MONTGOMERY COUNTY HISTORIC PRESERVATION COMMISSION
STAFF REPORT

Address:	1-A East Irving St., Chevy Chase	Meeting Date:	09/06/17
Resource:	Non-Contributing Resource Chevy Chase Village Historic District	Report Date:	08/30/17
Applicant:	Paul Brian & Geraldine Connolly	Public Notice:	08/23/17
Review:	HAWP	Tax Credit:	N/A
Case Number:	35/13-17EE	Staff:	Dan Bruechert

The applicant is proposing to remove a total of five windows, two on the left side, and three on the rear and to replace a set of paired rear doors. Additionally, the applicant is proposing to remove the applied pediment and construct a portico above the front addition. Staff supports approval for both of these elements.

Figure 1: 1 E. Irving (left) with a small portico with 1-A E. Irving (right) with an applied pediment.

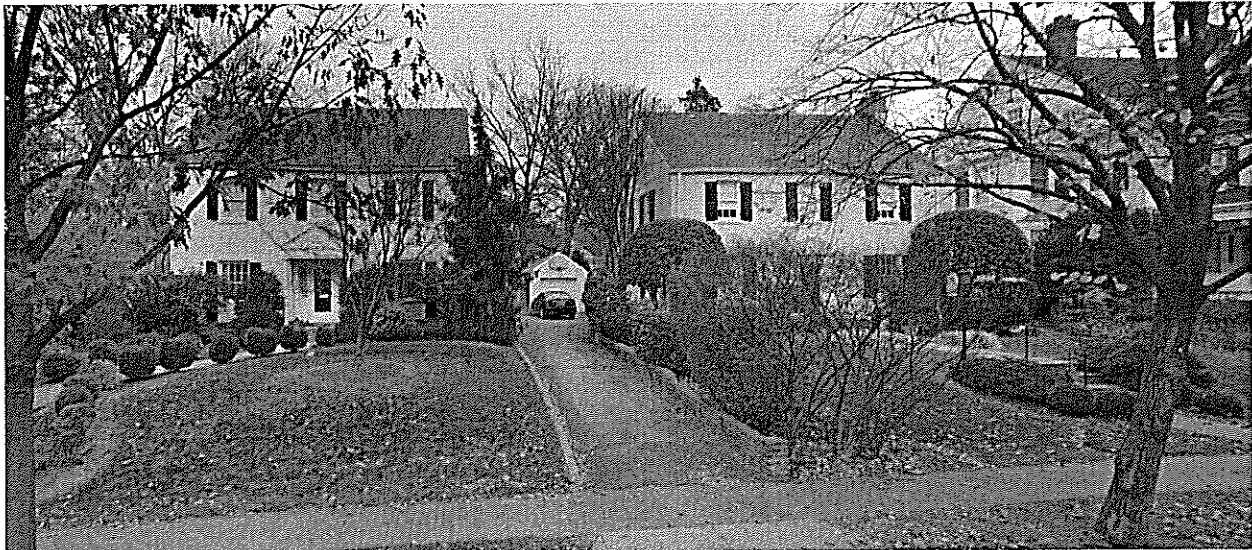
While the house, when constructed did not have a portico, there is a precedent for installing one on the house. The precedent is located directly next door (see Fig. 1, below). A house in matching details and dimensions has a small triangular portico over the front door. Staff has been unable to determine whether this element was added at the time of construction or later. The proposed portico at the subject property will be approximately the same size as its neighbor, but will read as a little larger due to the flat roof and railing above. Staff feels that while this proposal is more massive than what is done at its neighbor, it will not overwhelm the building, nor will it negatively impact the surrounding district.

The materials (wood) and design for the proposed portico are largely in keeping with the surrounding historic district. The applicant has provided a photo of this design installed at another house (see Circle 20, unidentified address). Lastly, this portico will not have a significant impact on the integrity of the house and may be removed without significant damage to the house at a later date. Because the *Design Guidelines* state that out of period/non-contributing resources should be given the most lenient level of review, Staff supports this proposal.

WINDOWS AND DOOR TO BE REPLACED
CIRCLED IN RED ARE TO BE REPLACED

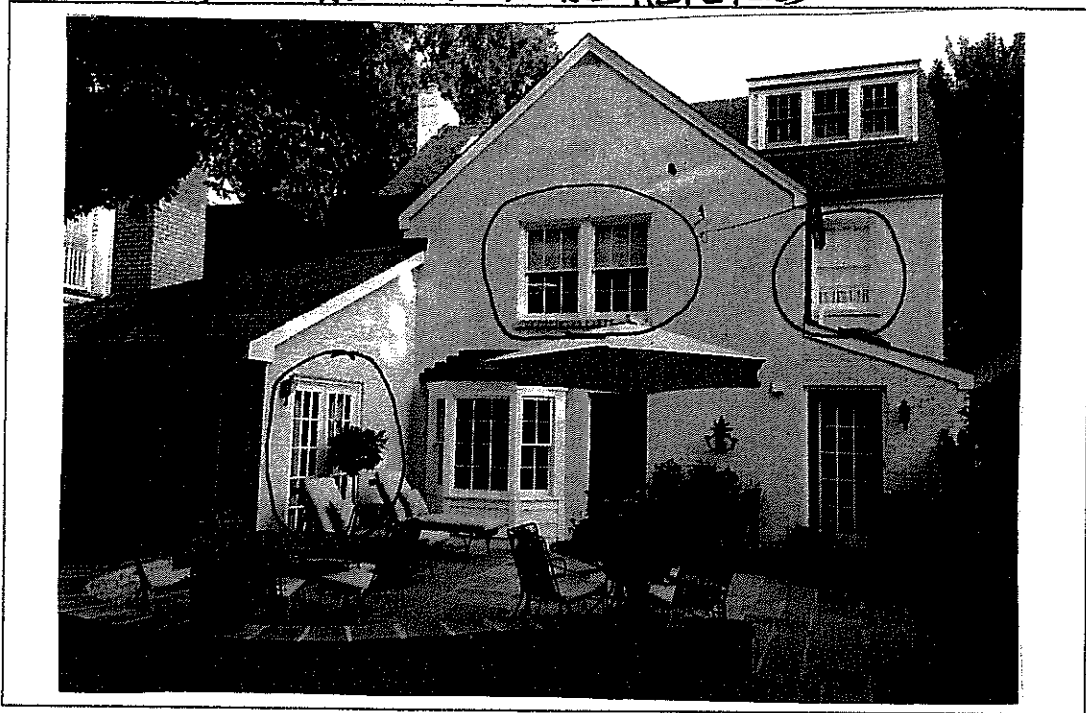
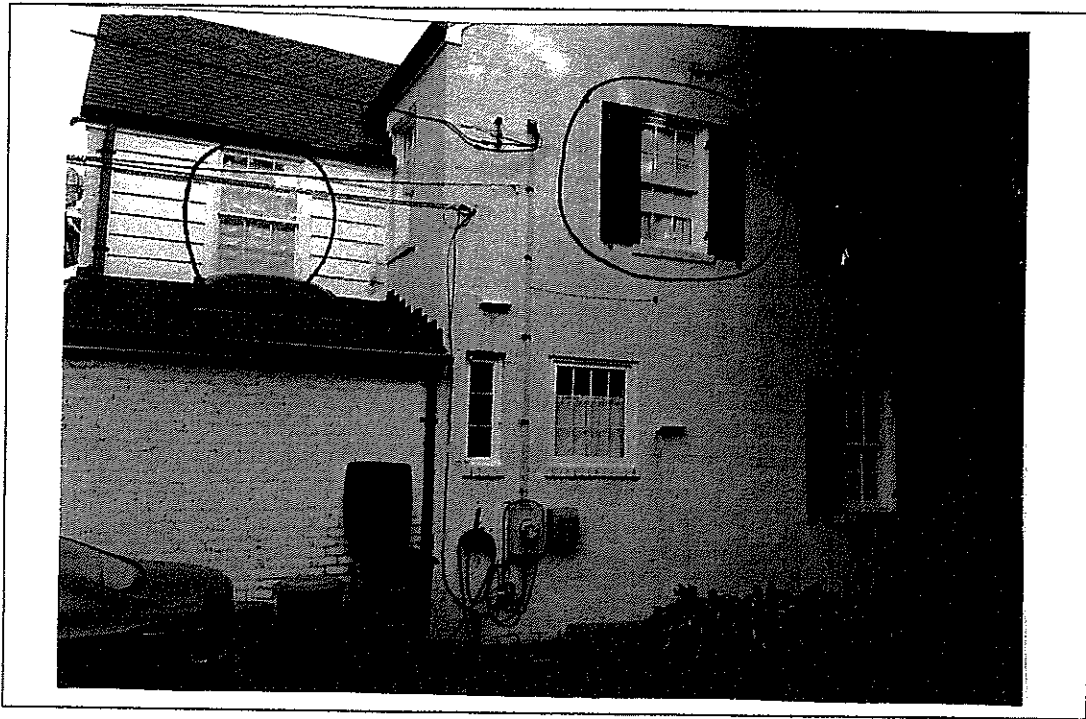
The three windows proposed at the rear are not at all visible from the public right of way and are to be reviewed under lenient scrutiny. These proposed windows will match the configuration and general appearance of the existing windows and *Guidelines* for the district state this change should be approved as a matter of course.

The proposed replacement doors will match the visual appearance of the non-historic doors and, as they are not visible from the public right-of-way, Staff feels that these should be approved as a matter of course.

SHEET TITLE
 FLOOR PLAN,
 FRAMING PLAN,
 EXTERIOR
 ELEVATIONS
 DRAWING NUMBER

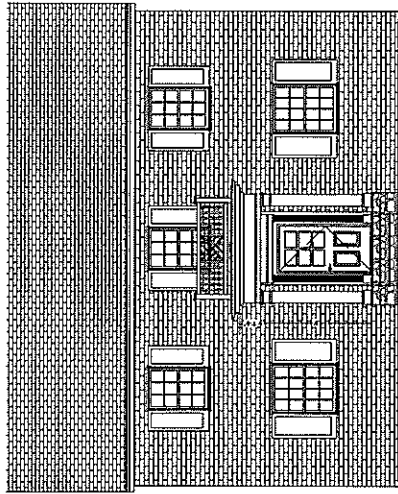
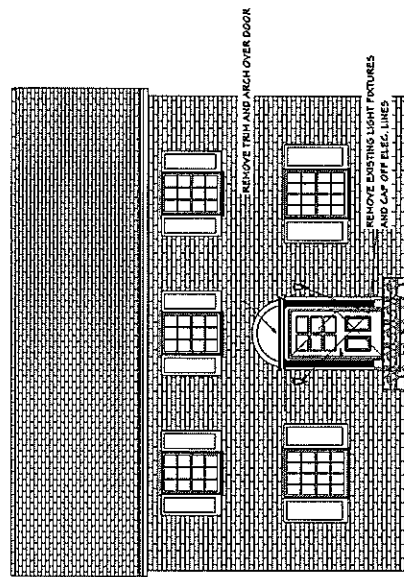
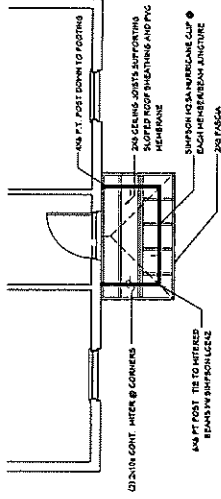
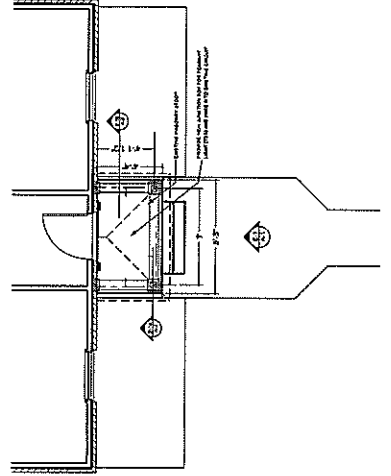
The applicant is proposing to construct a 4' by 8' (four foot by eight foot) portico over the front entrance. Currently there is an applied half-round pediment above the front door. Because this is a non-contributing resource, Staff believes that this proposal is appropriate.
